PALM BEACH COUNTY PROJECT NO. 2013529 & 2013529A

PROJECT LOCATION/LIMITS: Roebuck Road from Jog Road to Haverhill Road and Roebuck Road/Jog Road Intersection.

CHANGE ORDER

CHANGE ORDER NO: 14 (Fourteen)
COUNTY PROJECT NO: 2013529/2013529A
CONTRACT DATE: September 26, 2017
RESOLUTION NO: R2017-1196
DISTRICT NO: 2 and 7

DATE: MARCH 2019
P.A. NO. WA160.10
DWG. NO. 43-42-11-42
SHEET: A1-3

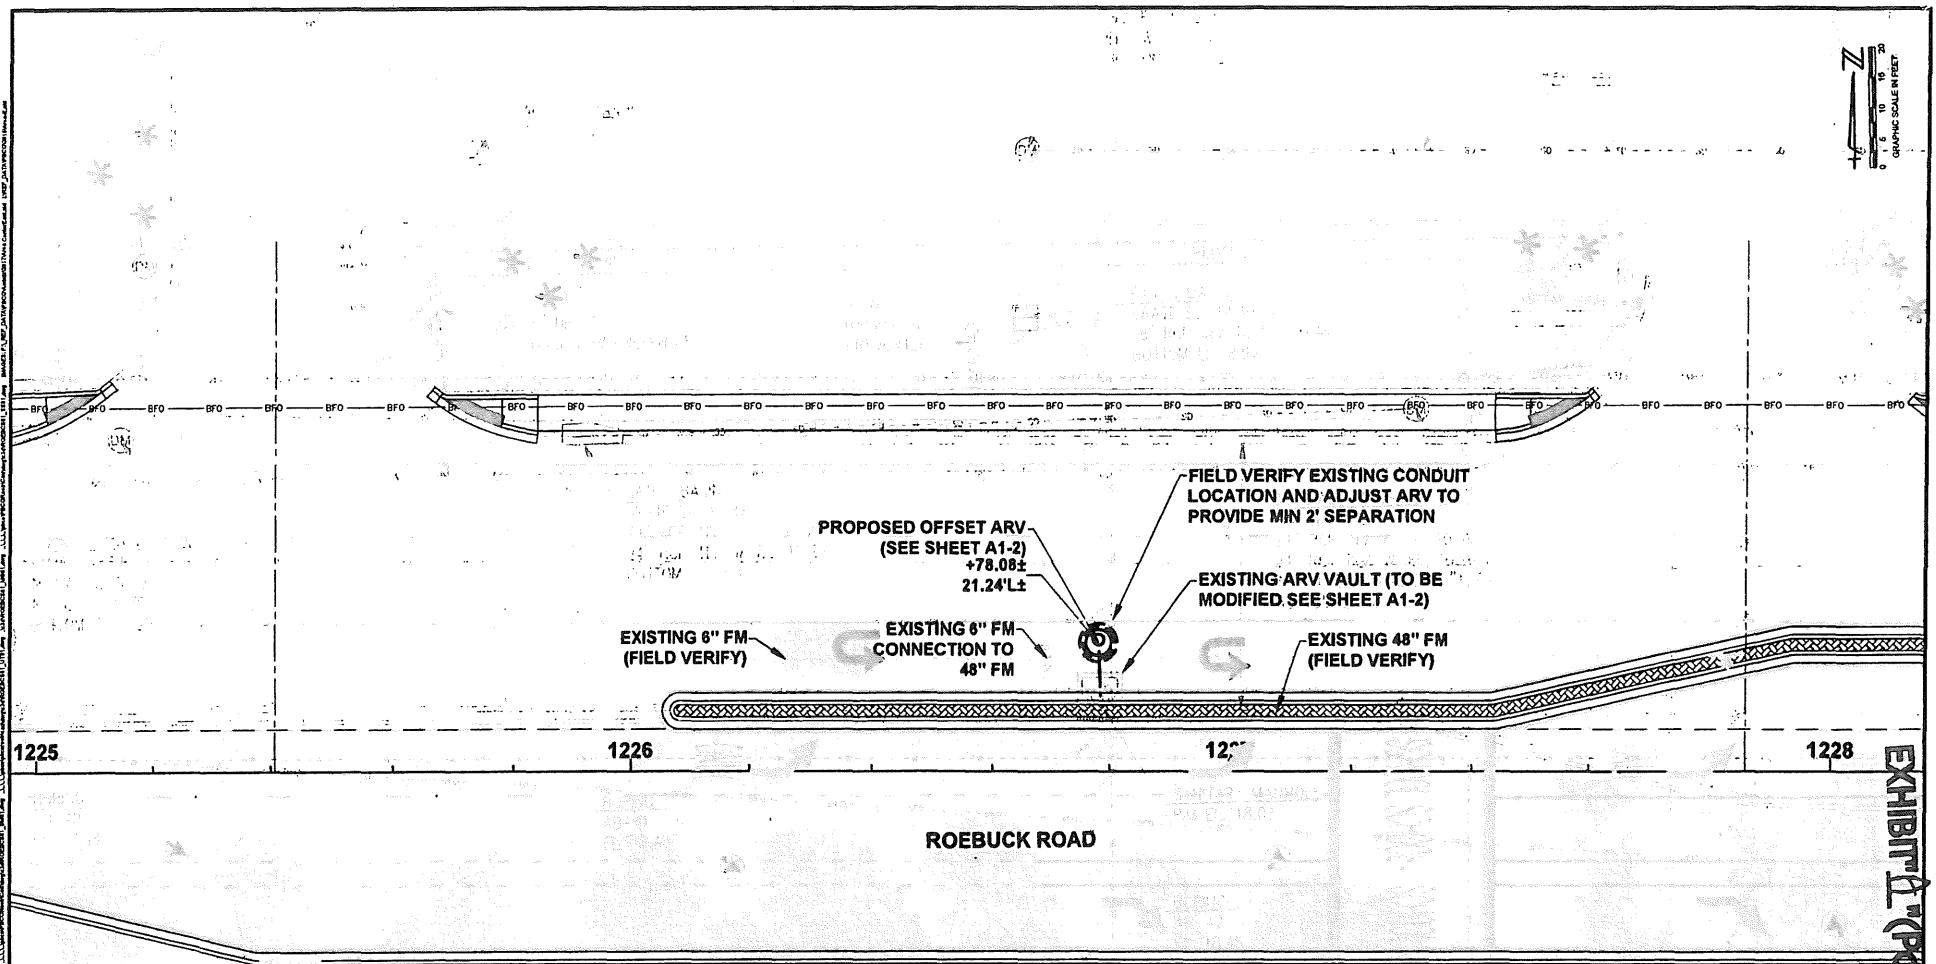
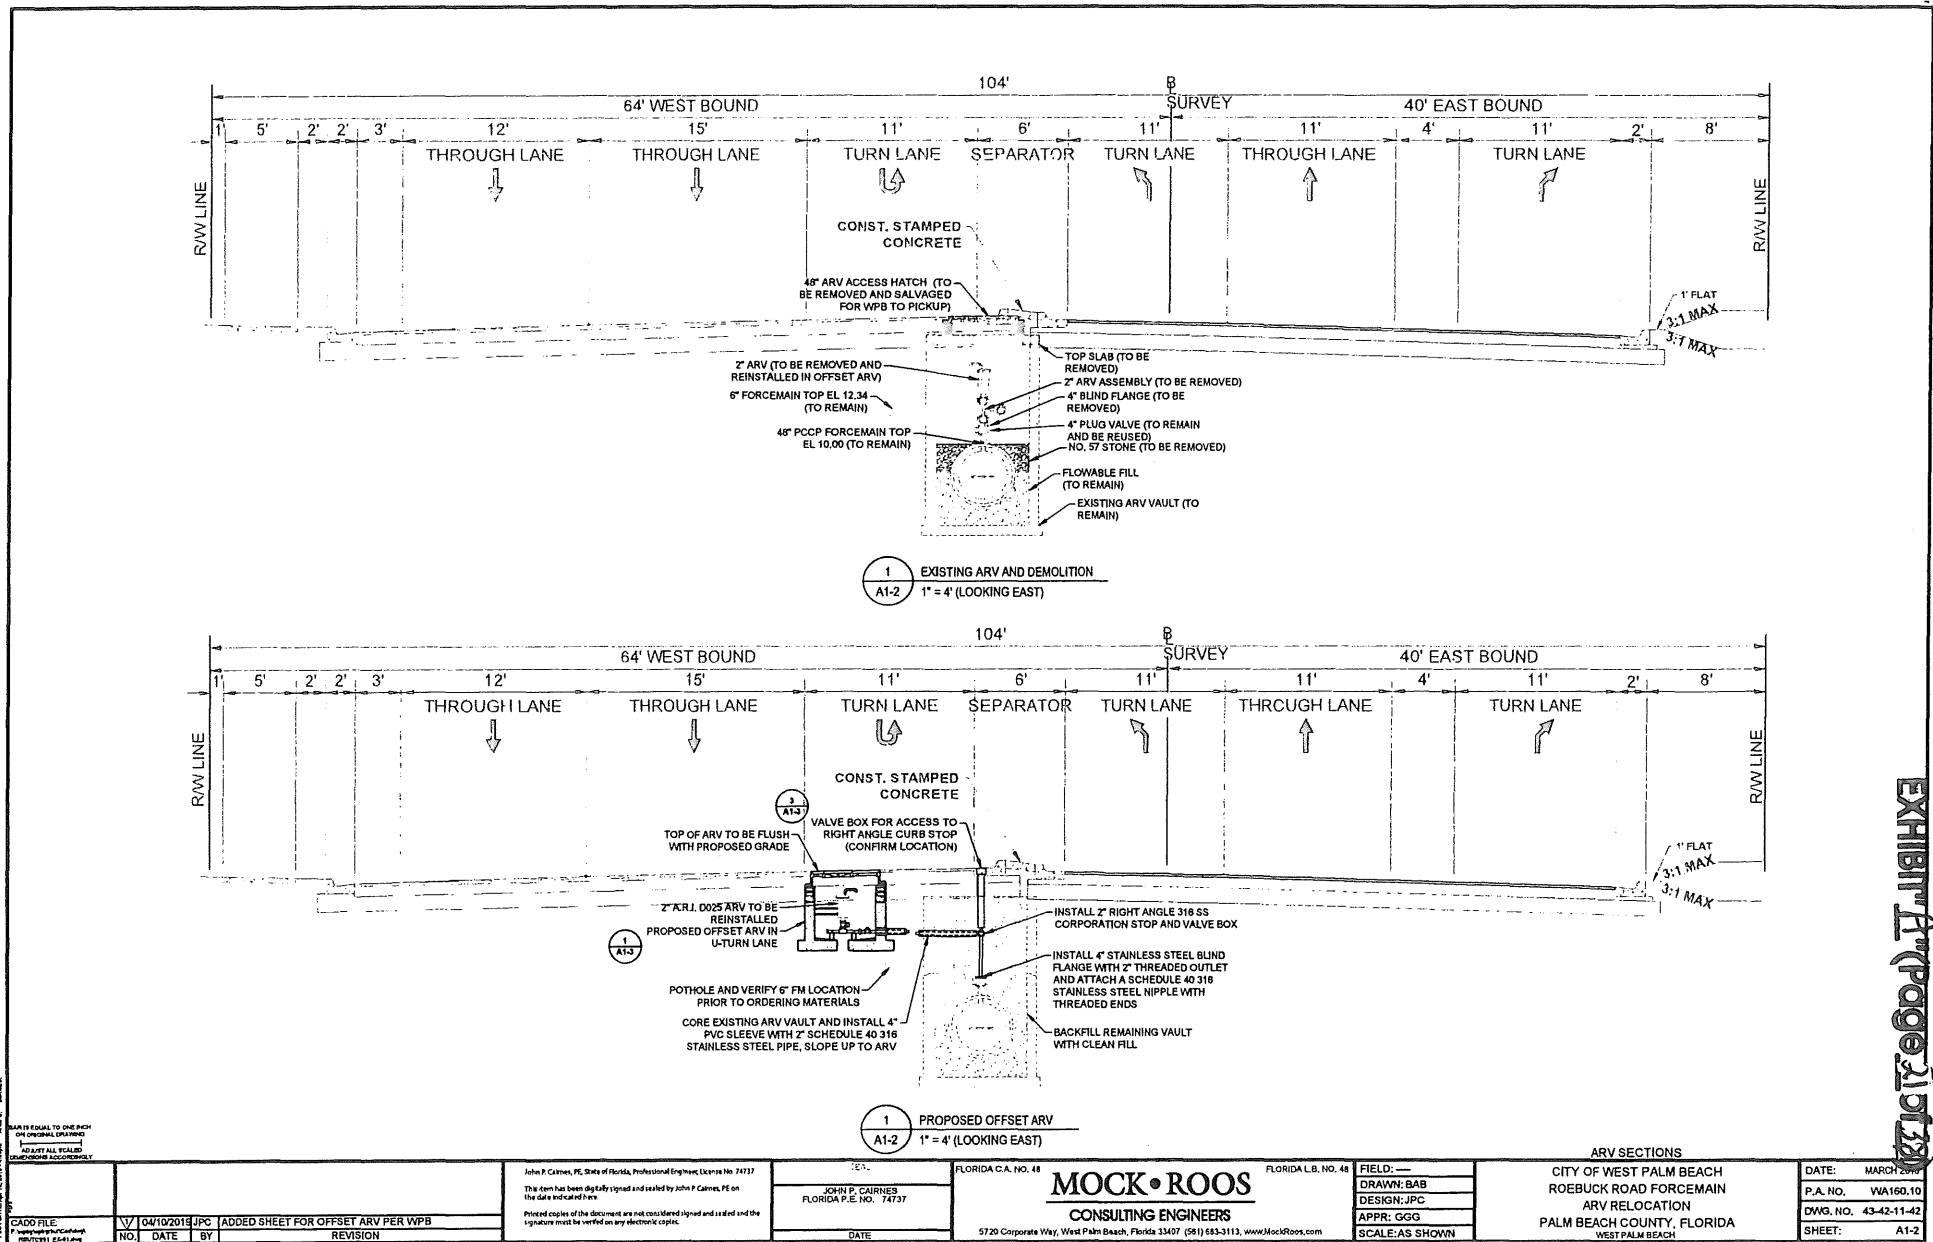
Plan revision for ARV relocation \$24,135.85

DESCRIPTION OF WORK: ARV relocation per plan revision.

The following is our change order related to the relocation of existing MH with furnishing a new ARV MH for the City of West Palm Beach. Please provide approval at your earliest convenience. Excludes: MOT, survey & as-builts, testing, restoration (other than backfill), NPDES, bond, permits, roadway sawcut, disposal of un-suitable materials.

CADD FILE	NO.	DATE	BY	REVISION
04/10/2019	JPC	ADDED SHEET FOR OFFSET ARV PER WPB

DATE: MARCH 2017
 P.A. NO. WA180.00
 DWG. NO. 43-42-11-41
 SHEET: C1-4

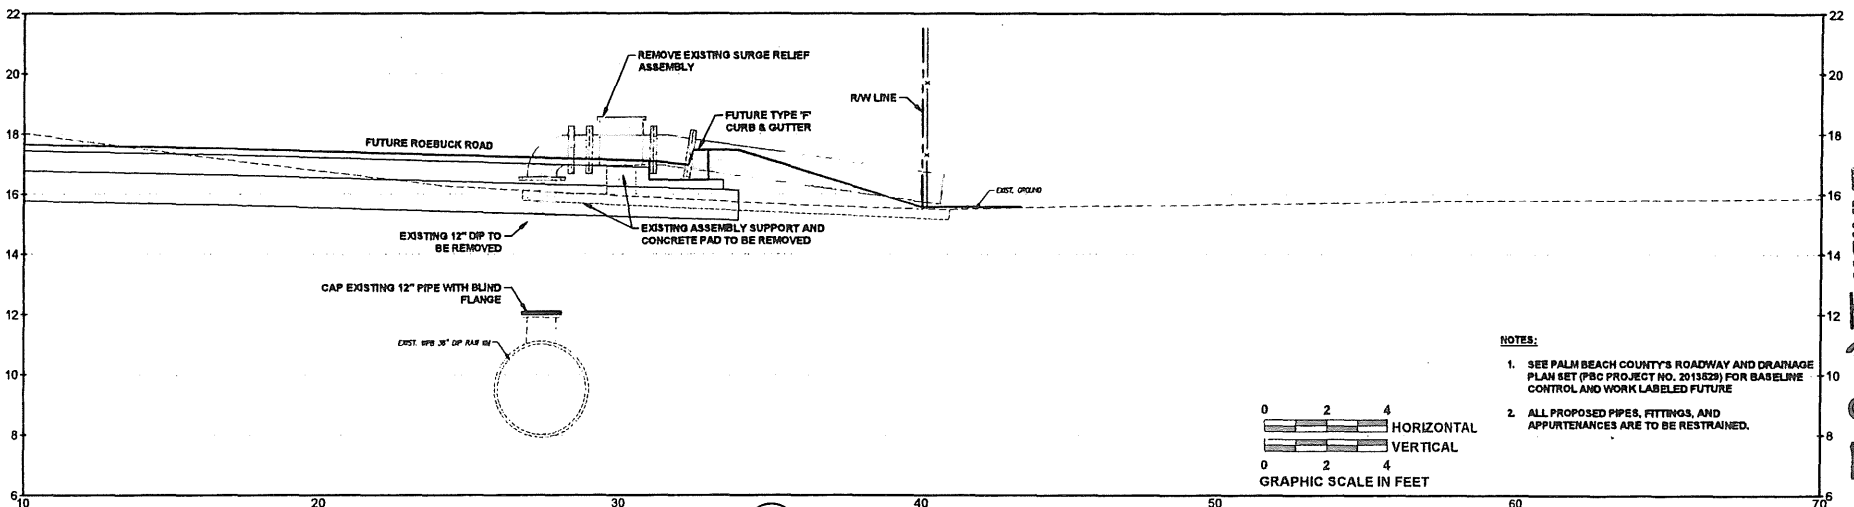
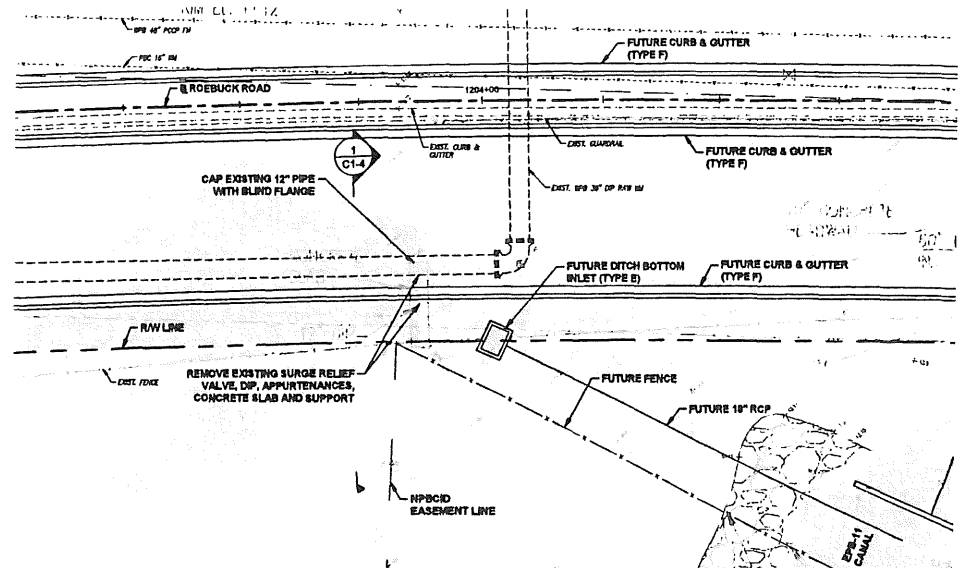
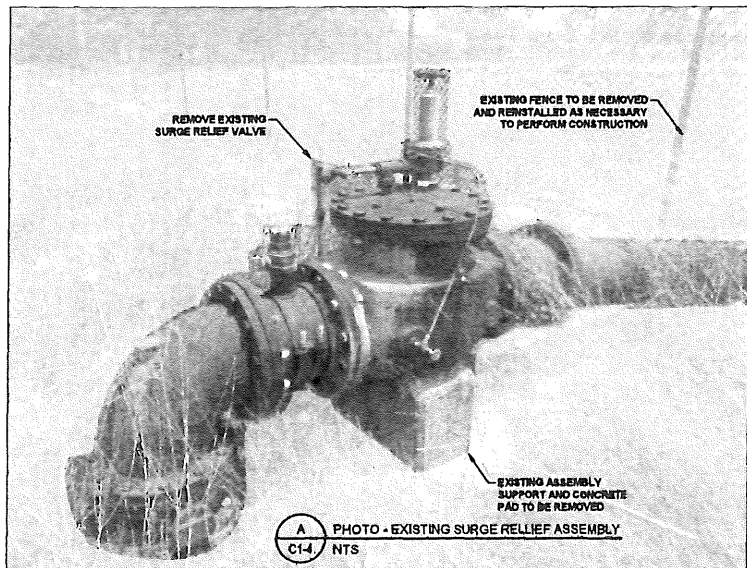
RFI Title: Existing Surge Relief Valve

Reference: Sheet C1-4

- During a site visit to the site location of the existing City of West Palm surge relief valve, we determined that the valve appears to be in very poor condition with little maintenance done to it. An existing ARV valve showed to be broken and rotten. Part of our scope is to relocate the complete apparatus outside of the travel lanes and behind the relocated fence. Please advise if the plan is in fact to keep the complete apparatus as it appears to be in poor shape. JD cannot be held responsible if it breaks during the relocation as we believe the apparatus might not survive the relocation. Please advise. See attached pictures for your records.

- The City of West Palm Beach has determined that the existing surge relief valve can be removed (per WPB email on June 15, 2018). The Contractor shall coordinate with the Darrel Graziani (contact information below), City Water Plant Manager, to have the raw watermain taken out of service, remove the existing surge relief valve, appurtenances, DIP, concrete pad, and concrete supports and cap the connection to the raw watermain with a blind flange. Prior to beginning work, the contractor shall provide a credit for the reduced scope of work for the City's review and acceptance. See attached drawing (last revised June 27, 2018) for additional detail.
